Explanation of Significant Differences
for the
Upper and Lower Harbor Operable Unit
New Bedford Harbor Superfund Site
New Bedford, Massachusetts

August 2002

U.S. Environmental Protection Agency
Region I - New England
Boston, MA

**New Bedford Harbor Superfund Site
August 2002 Explanation of Significant Differences
U.S. EPA - New England**

Figure 2
Shoreline Facilities for Offsite Disposal
February 2002 ESD

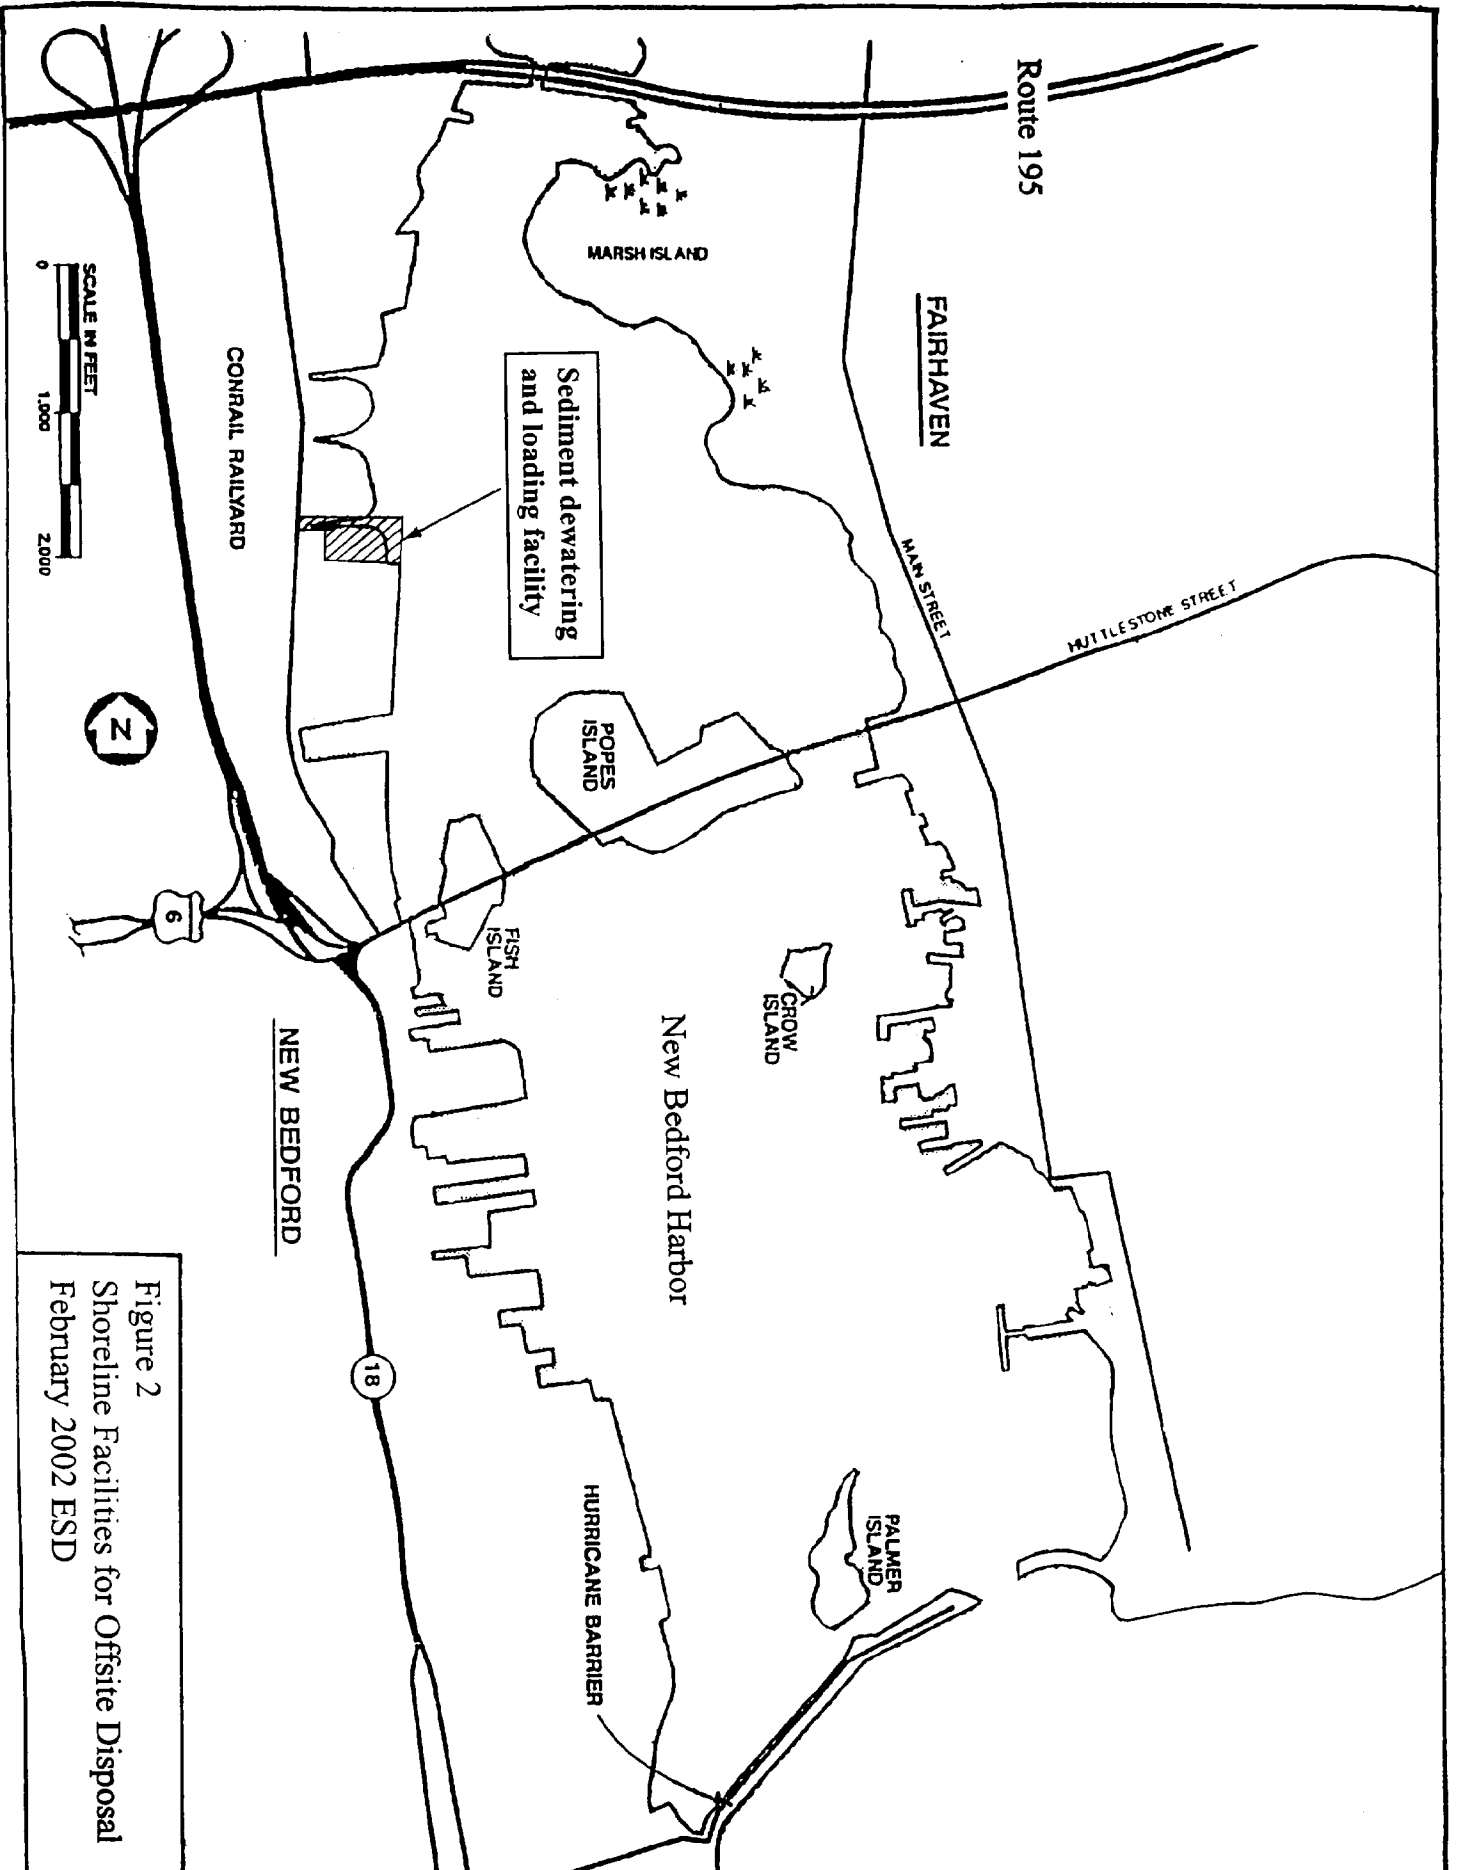
While this ESD eliminates the 17 acre CDF D, it does not eliminate extension of the rail spur into this area discussed in the September 2001 ESD. Instead of CDF D, a smaller shoreline facility will now be constructed in the same area to support both the sediment dewatering building and the rail car (or truck or barge) loading area required for offsite disposal of the dredged sediments. See Figure 2 for the location of this smaller dewatering and transfer facility. Figure 3 illustrates the larger area of fill that would be required for CDF D, based on the original conceptual design. Figure 4 provides a closer overhead view of the smaller dewatering and loading facility, as currently designed.

FIGURE 4

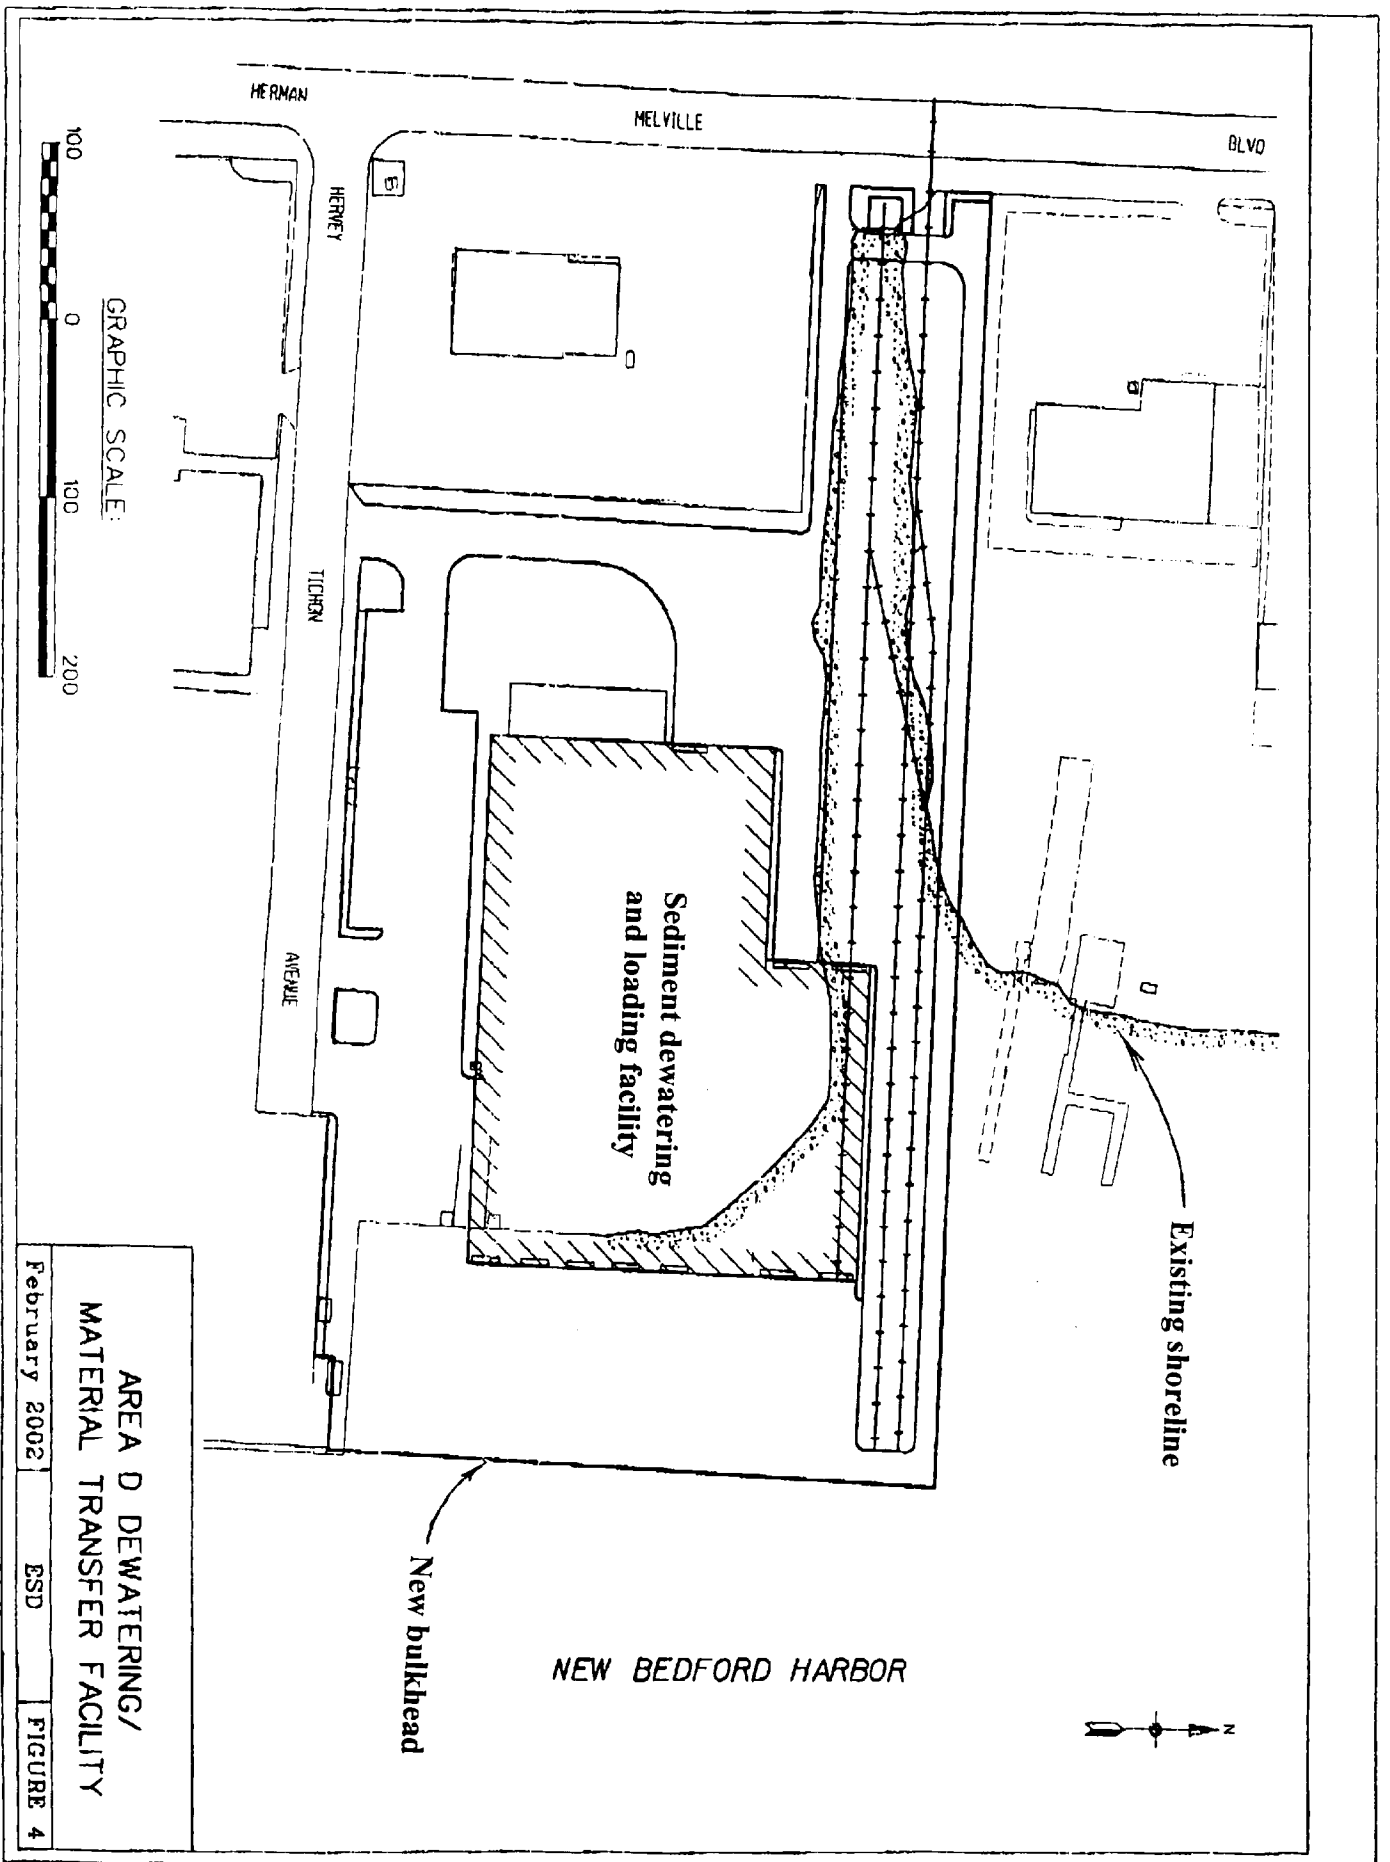
Under the offsite disposal option, the smaller scale shoreline facilities - the bulkhead, dewatering warehouse and rail spur - would be designed for future commercial marine reuse. Thus beneficial reuse of these facilities within the DPA once the cleanup is complete would be vastly streamlined and much less limited. Figure 4 shows a plan view of these features as currently designed.
